# Access Compliance Report

## Public Rights-of-Way

### (Curb Ramps)

Intersection ID: 54204	Main Street: APRIL_YIXUAN_LN	Cross Street: N_TRYON_ST	Location: NW
ADA ID: CD7189BC542E	Ramp Type: Perp	Initial Pass/Fail: Fail	Overall Compliance: No
		Severity Score: 1.25

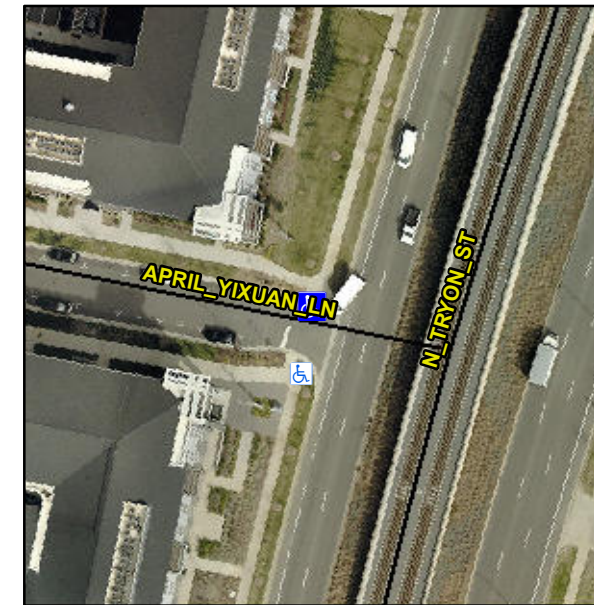
**Not Found, R304.5.3**

Compliance	Description	Data	Compliance	Description	Data
N/A	Ramp Length (in)	96.0	Yes	Ramp Slope (%)	7.9
Yes	Ramp Width (in)	48.0	No	Ramp XSlope (%)	3.1
N/A	Flare Type LT	N/A	N/A	Flare Type RT	N/A
N/A	Flare Slope LT (%)	N/A	N/A	Flare Slope RT (%)	N/A
N/A	Flare Traversable LT?	N/A	N/A	Flare Traversable RT?	N/A
N/A	Landing Length (in)	N/A	N/A	DWS Provided?	N/A
N/A	Landing Width (in)	N/A	N/A	DWS Contrast?	N/A
N/A	Landing Slope (%)	N/A	N/A	DWS Length (in)	N/A
N/A	Landing X Slope (%)	N/A	N/A	DWS Full Width?	N/A
N/A	Landing Curb? (Y/N)	N/A	N/A	DWS Offset (in)	N/A
N/A	Shared Landing?	N/A			
N/A	Gutter Ponding?	N/A	N/A	Gutter Slope (%)	N/A
N/A	Gutter Lip Ht (in)	N/A	N/A	Gutter X Slope (%)	N/A
N/A	Painted X Walk1?	No	N/A	Painted X Walk2?	N/A
	X Walk 1 Direction	To S		X Walk 2 Direction	N/A
N/A	X Walk 1 Width (in)	N/A	N/A	X Walk 2 Width (in)	N/A
	X Walk 1 Slope (%)	0.1		X Walk 2 Slope (%)	N/A
	X Walk 1 X Slope (%)	2.8		X Walk 2 X Slope (%)	N/A

**Remove & Replace Entire Ramp.**
